SUBJECT: ISSUANCE OF AMENDMENT NO. 113 TO FACILITY OPERATING LICENSE
NO. DPR-51 - ARKANSAS NUCLEAR ONE, UNIT NO. 1 (TAC NO. 69056)

AMENDMENT TO FACILITY OPERATING LICENSE

Amendment No. 113
License No. DPR-51

SAFETY EVALUATION BY THE OFFICE OF NUCLEAR REACTOR REGULATION

FIGURE NO. 2.1-1

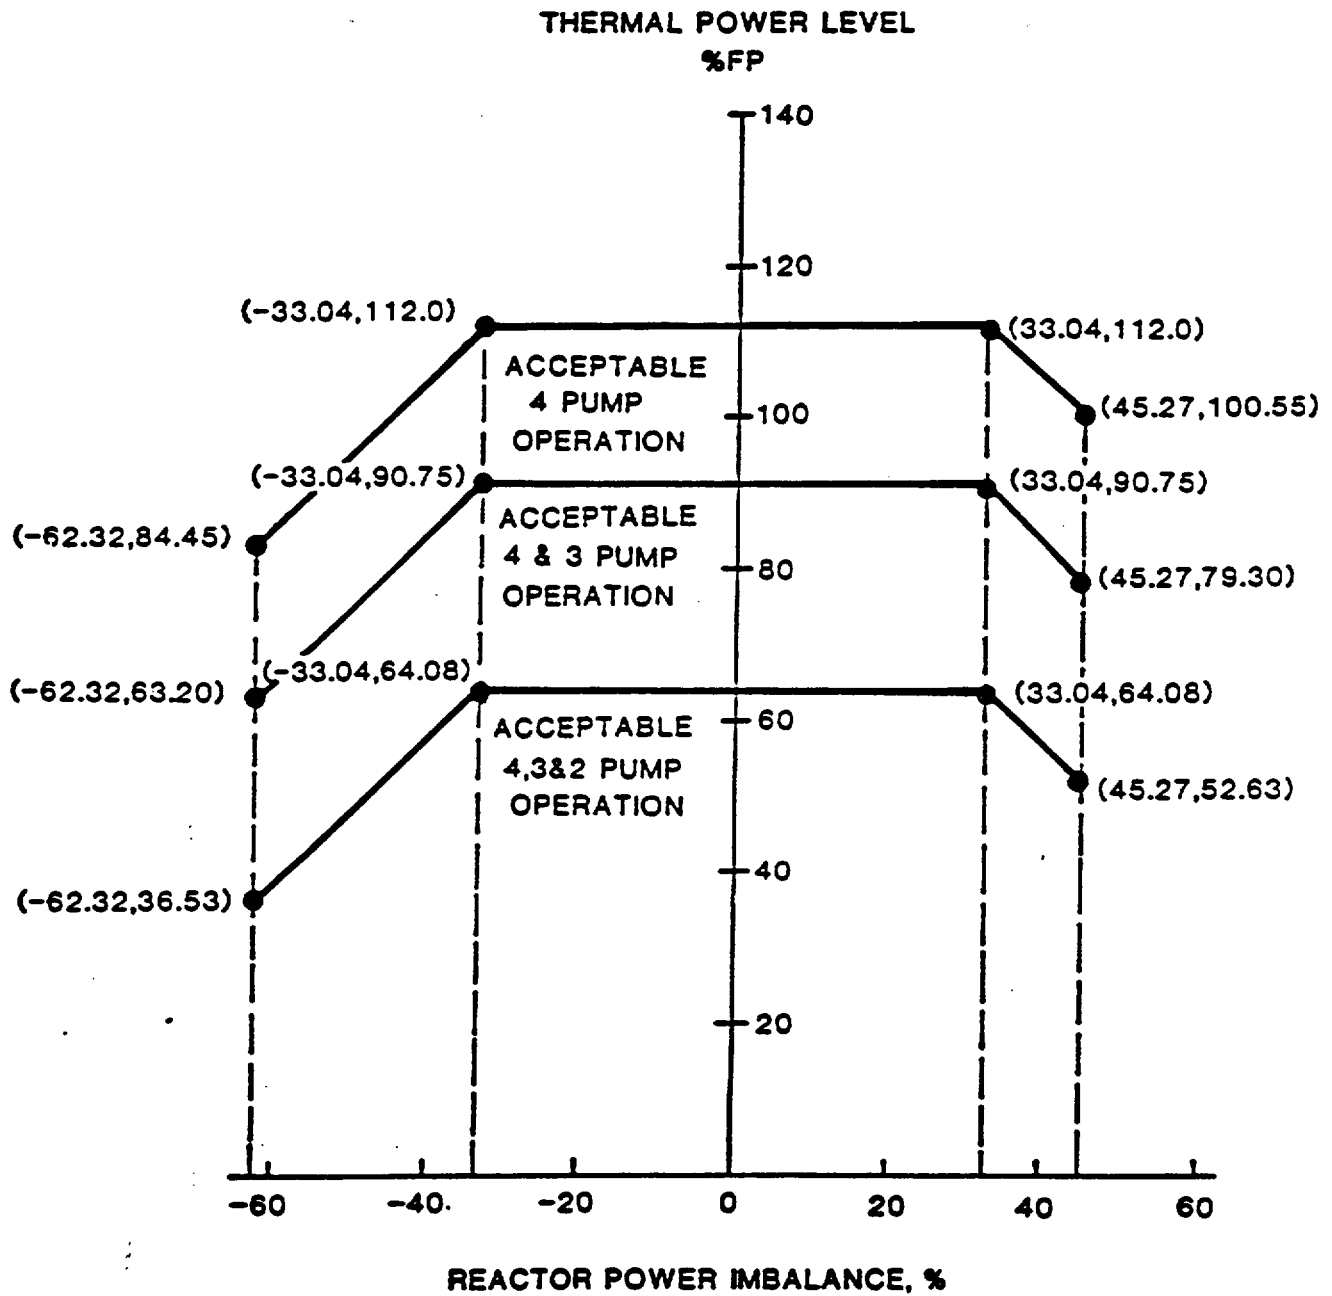
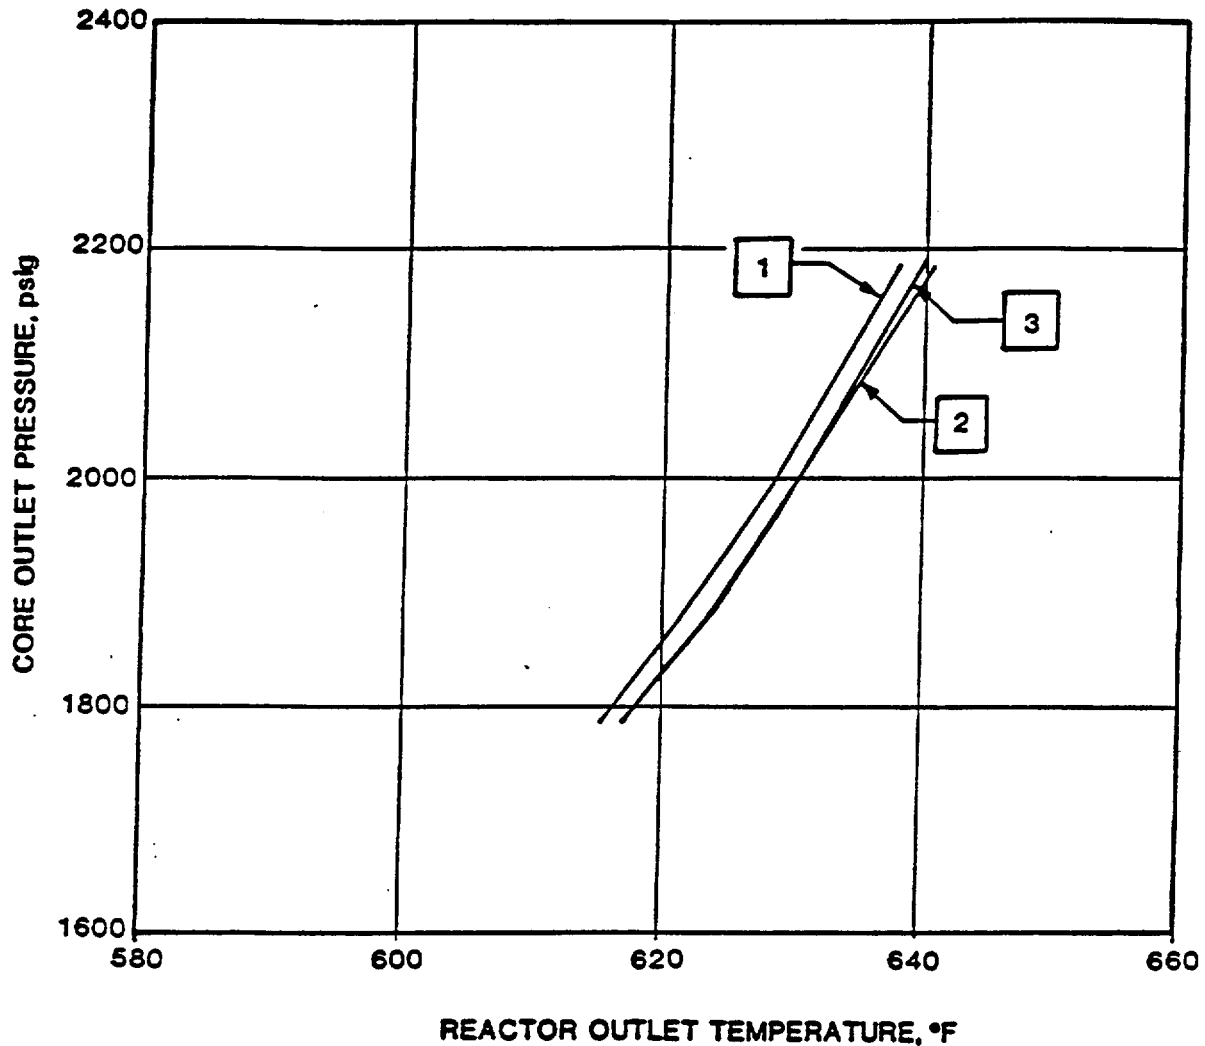
Figures 2.1-1, 2.1-2, 2.1-3 and the bases to TS 2.1
Figures 2.3-1, 2.3-2, Table 2.3-1 and the bases to TS 2.3

These sections are modified to reflect the mixed core of fuel assemblies with Inconel and Zircaloy spacer grids, and to use cycle specific credits. Also included is a revised variable low pressure trip setpoint.
